Subject: Supplemental Response to Data Request #40 (11-AFC-04)

SUPPLEMENTAL RESPONSE TO DATA REQUEST #40

Technical Area: Transmission System Engineering

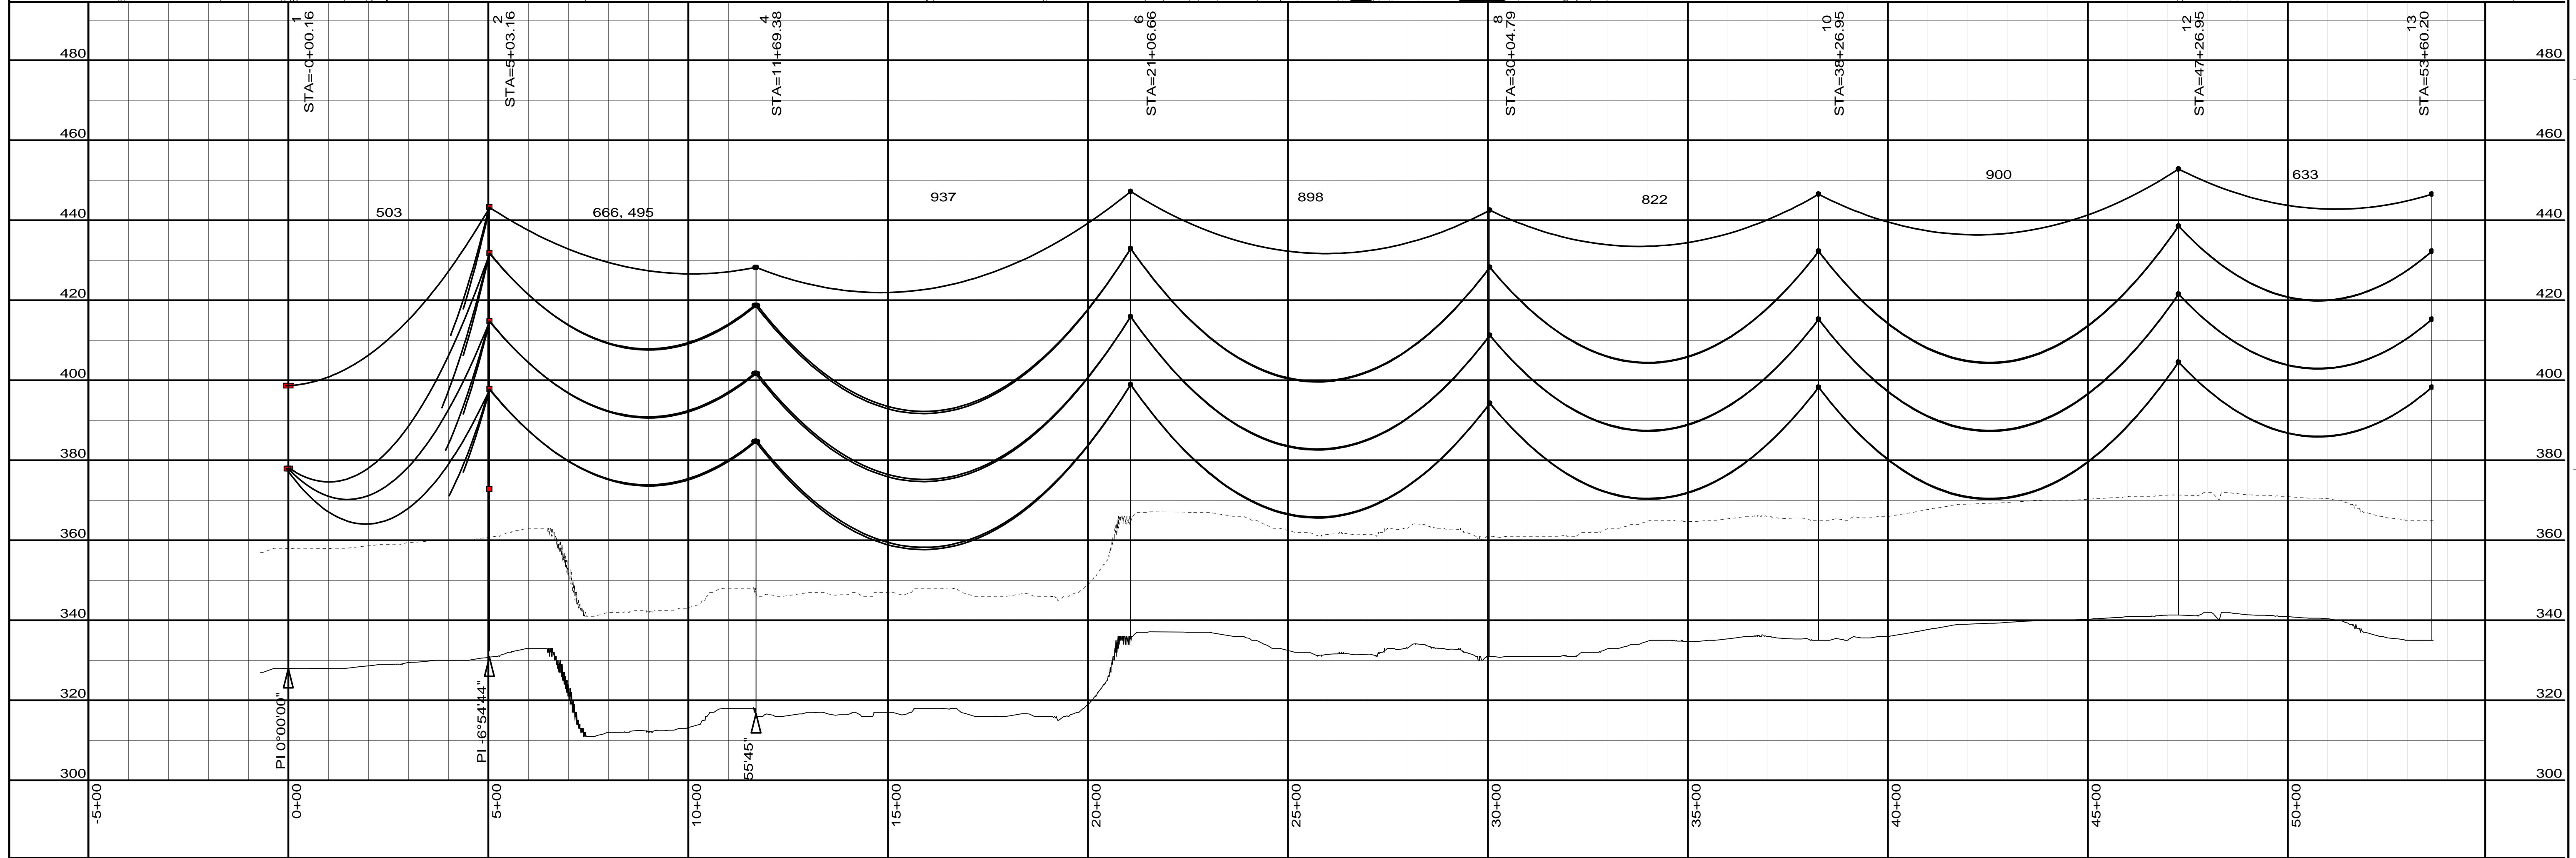
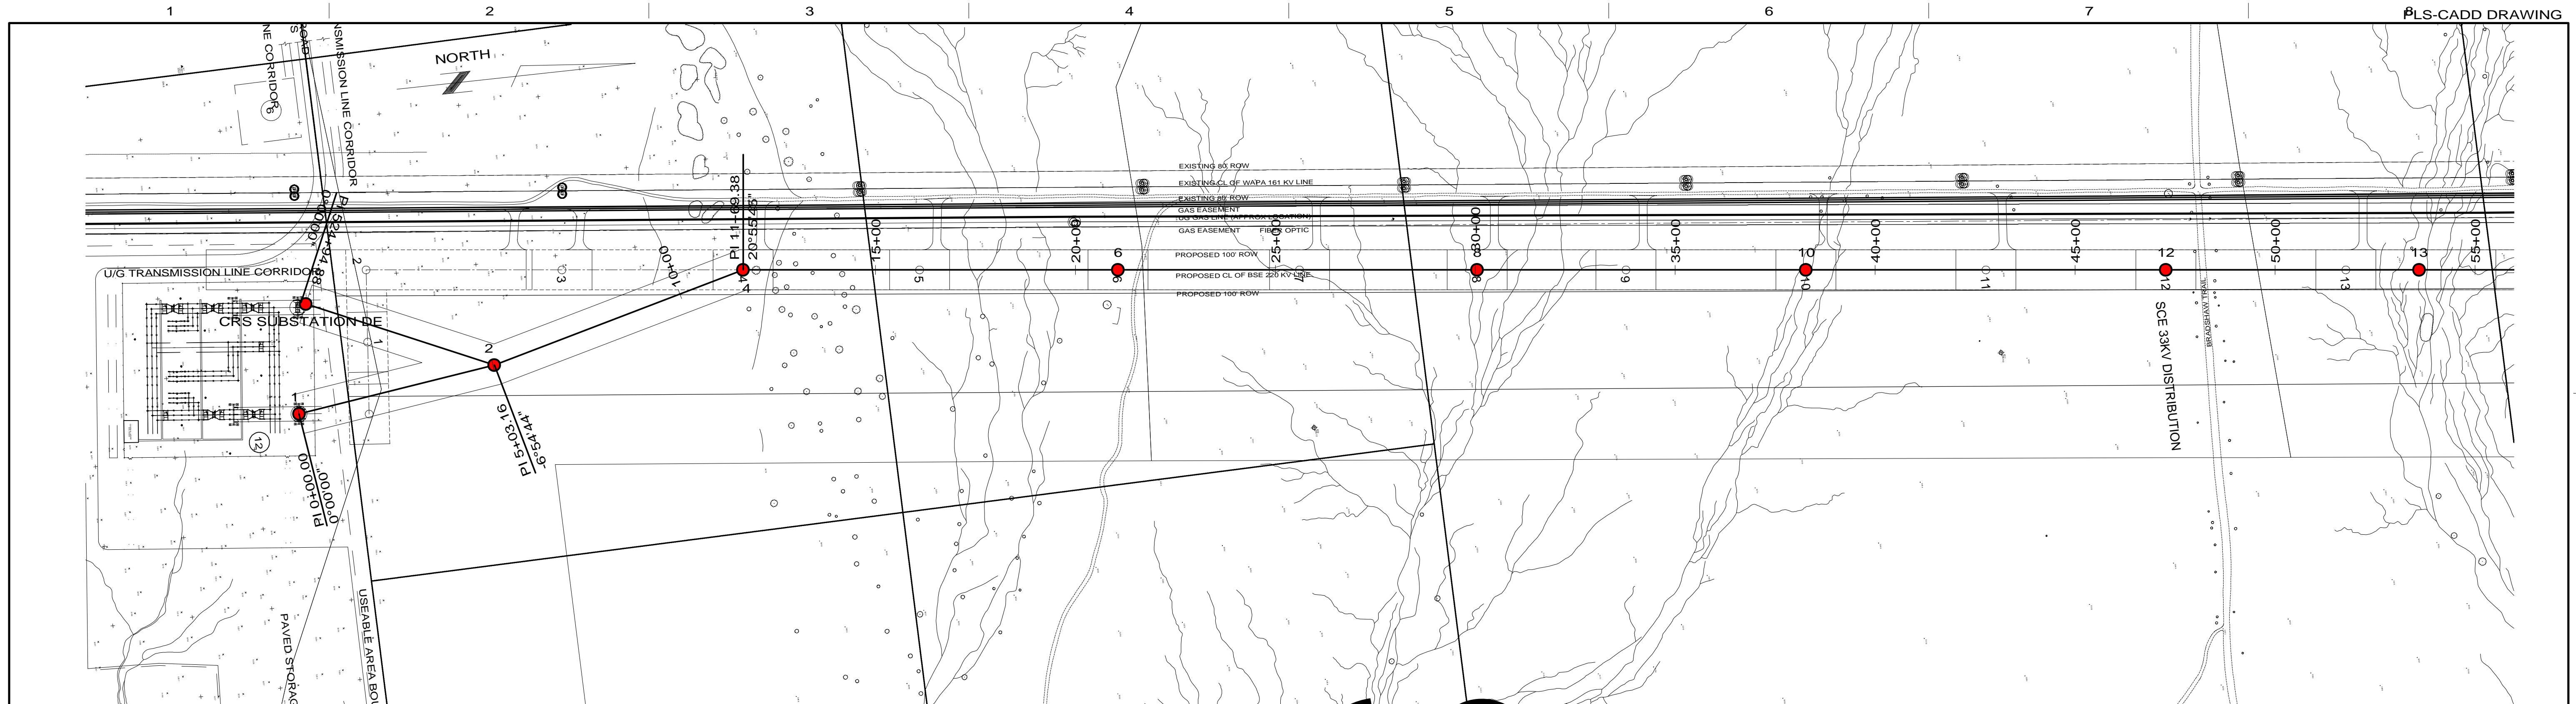
Please elaborate on the discrepancies between the BLM and SCE records that you reference. We need to understand this better as an offset of a portion of the gen-tie route would require consideration in a number of technical areas and would also effect the project description. Also provide a timeline of when the ROW issues are intended to be resolved.

During the due diligence process for the Rio Mesa generator tie line (Gen-Tie line), the Applicant discovered a BLM linear ROW granted to Southern California Edison (SCE) back in the 1980's (the "SCE ROW"). The SCE ROW seemed to be intended to accommodate the future extension of the Devers-Palo Verde – 2 (DPV-2) transmission line. The Applicant wanted to design the Project's proposed 230Kv Gen-Tie line to run in the vicinity of the SCE ROW, but Applicant was concerned that its preferred Gen-Tie route would interfere with a portion of the SCE ROW mapped by BLM.

To avoid ROW conflicts, the Applicant initiated a discussion with SCE to explore whether a segment of the SCE ROW could and/or would be realigned to accommodate Applicant's preferred Gen-Tie route. During Applicant's discussions with SCE, it was discovered that BLM's records and SCE's records were inconsistent. As mapped by the BLM, the SCE ROW is generally located *south* of the existing Devers-Palo Verde – 1 (DVP-1) line. However, SCE's records depict the SCE ROW for DPV-2 as being located *north* of the existing DPV1 line. SCE is proceeding with construction of the Colorado River Substation (CRS) and DPV-2 transmission line based on its own ROW records. If the SCE records are correct, there is no need to realign the SCE ROW for DPV-2 in order to accommodate the proposed RMS Gen-Tie line routing.

The Applicant requested that SCE and BLM reconcile the SCE ROW records for DPV-2 and both parties agreed to do so. Although Applicant has not yet been provided final confirmation that the BLM and SCE records have been reconciled, the Applicant has adjusted the proposed RMS Gen-tie line route to be south

of and adjacent to the existing DPV-1 line, in accordance with BLM guidelines. The resulting Gen-tie line segment from the where it crosses the WAPA 161kV transmission line northwest to the CRS has been shifted to the north 200' – 300' from the route depicted in the AFC. Applicant believes that this slight variation in routing is not considered a material change since the adjusted routing is still within the biological and cultural study area.

Attached are the new Plan and Profile (P&P) drawings showing the adjusted Gen-tie line routing and the location of all 67 poles as well as the Dead-end structure at the CRS. Also attached are 2 typical Pole configurations that are expected to be used for the Gen-tie Overhead transmission line.
